**OFFICIAL AGENDA
PLANNING & ZONING COMMISSION
CITY OF STARKVILLE, MISSISSIPPI
MEETING OF TUESDAY, October 10, 2023
1ST FLOOR CITY HALL – COURTROOM
110 WEST MAIN STREET AT 5:30 PM**

To: Members of the Planning & Zoning Commission
From: Daniel Havelin, City Planner (662-323-2525 ext. 3136)
Lyle McCaskey, Assistant City Planner (662-323-2525 ext. 3130)
Subject: Discussion and consideration of AA 23-01 a request for an Administrative Appeal of the decision of the City's independent consultant to deny approval of the building design proposal of Cadence Bank at 400 University Drive in a T-5C zoning district
Date: October 10, 2023

RE: Architectural Review – Cadence Bank

Project Name: Cadence Bank- Starkville Midtown Branch Bank

MARK	DATE	DESCRIPTION
A	MAY 19, 2023	ACC SUBMITTAL
B	JULY 19, 2023	ACC RESUBMITAL
C	AUG 24, 2023	ACC RE-SUBMITAL

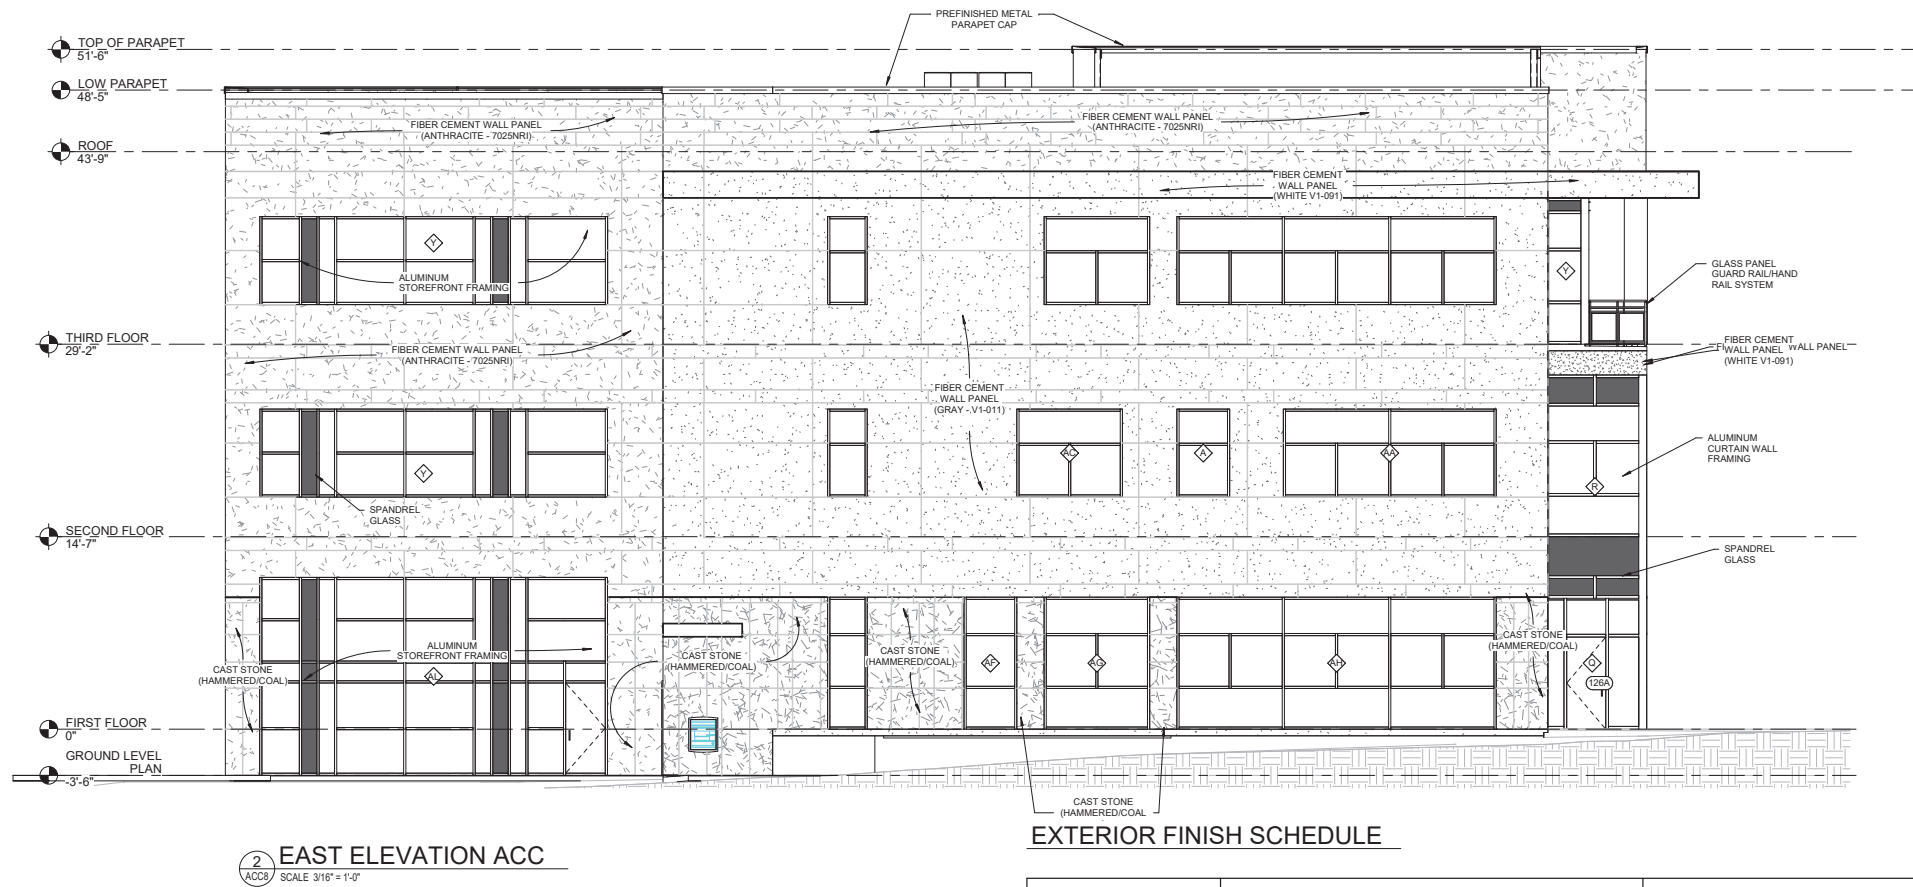
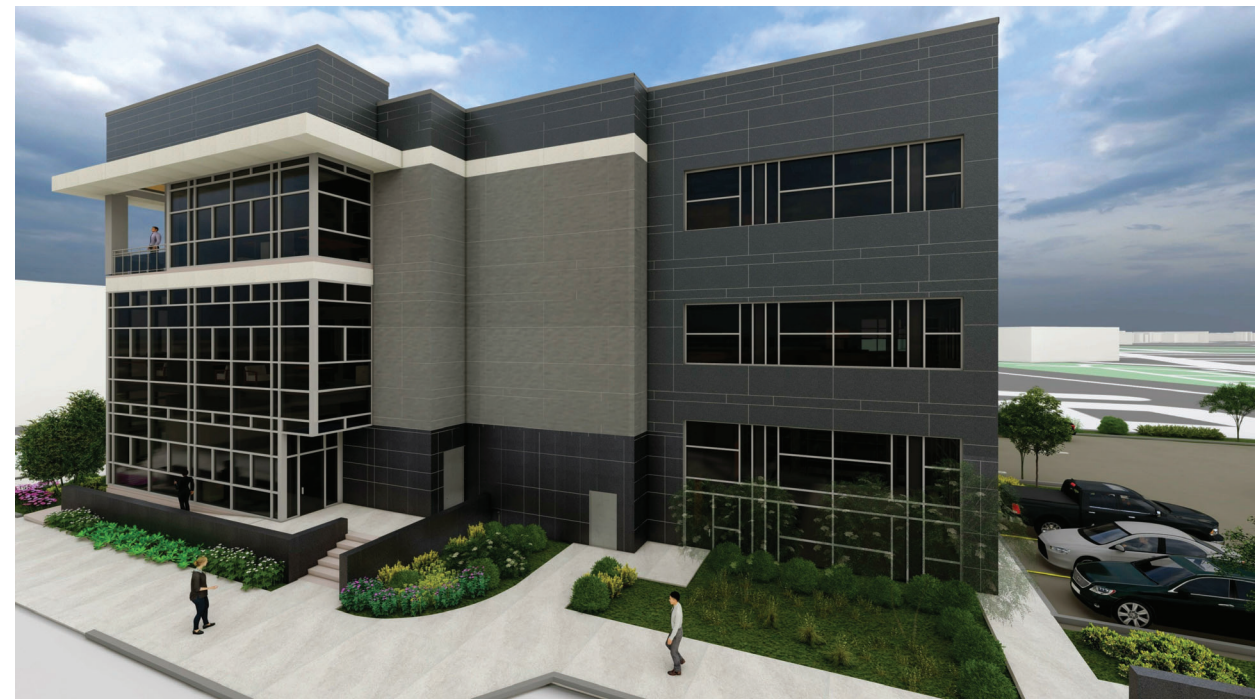
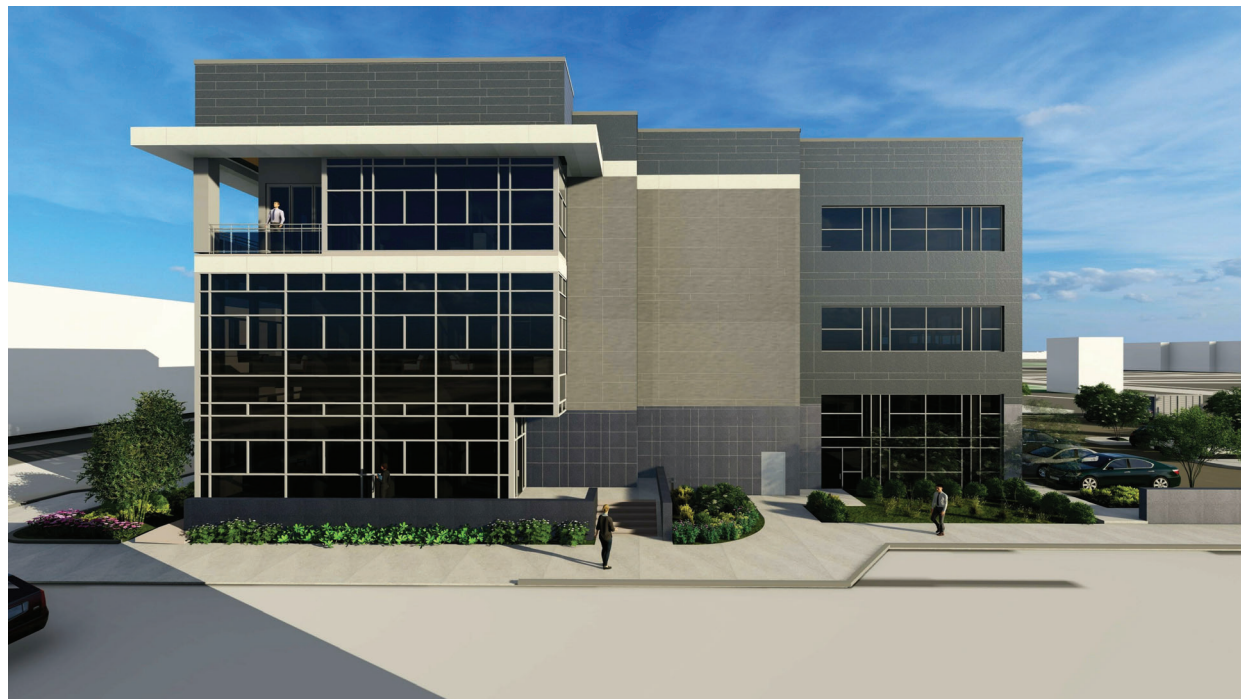
- 1. From the previous design we went from having no joint or pattern lines to a design that is very busy. The pattern and rhythms of the joints do not line up. For instance, the window patterns do not match the panel patterns so there would be extra cut lines in the panel patterns. The joint patterns do not look consistent either. I realize there are multiple colors and sizes of these panels, but it not a very streamline approach.***
- 2. The rendering of the model does not accurately reflect the texture and pattern of the materials. This is also making it difficult to decipher the exterior.***
- 3. The main entry does not face the street and is not clear.***

Overall, the proposed design does not align with what the committee and the city's objectives and vision for the building and site are. The committee would really like to see the building in masonry. Perhaps have a large-scale block base and brick above. Again, this is a major corridor thoroughfare and contextually in needs to be appropriate. When I previously questioned the white color, I did not mean that it had to completely go away or flip to the opposite color as the rendition has done. Also, having been a Cadence bank member for my entire life, I feel like the predominance of a bank should be felt and easily identified. The general aesthetic of the building, as it stands now, I feel is working towards a modern flare. I normally would be an advocate of such, but the context of this building is not appropriate. We please ask that you reevaluate the design and take into consideration the feedback from this and the previously supplied comments. If Mr. Daniels would like to send us some of these materials for in person review and make a case for the design, I certainly would be open to that communication.

The renderings show what is perceived at a distance from the building. The panel design is more about the larger elements of color. Prominent lines of window mullions catch your eye and are leading vertically and horizontally connecting to the larger elements of color and materials that make up the building.
